GTHT - _____1_____

PITS/PONDS

DECEMBER 17, 2013

RE: Lightning Dock Geothermal Project (GTHT-001): "Reserve Pit Closure Plan"
Lightning Dock Geothermal HI-01, LLC, Hidalgo County, New Mexico

POND SURVEY

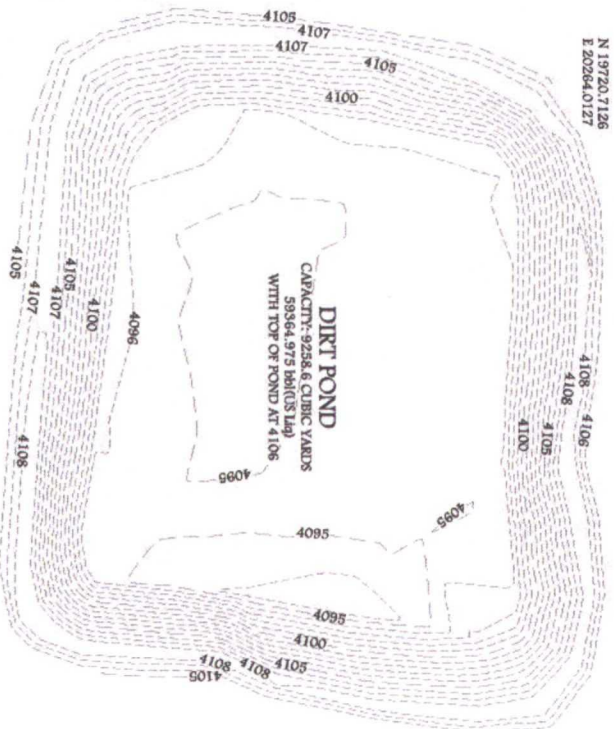
The pond appears to be a dirt pond. This does not adequately address NM's pond construction requirements for containing produced oilfield waste. If this is indeed the pond construction that Cyrq Energy, LLC is planning to submit to the OCD, please review OCD Regulations, i.e., Rule 36 "Evaporation Pond" and/or Rule 17 "Permanent Pit" language.
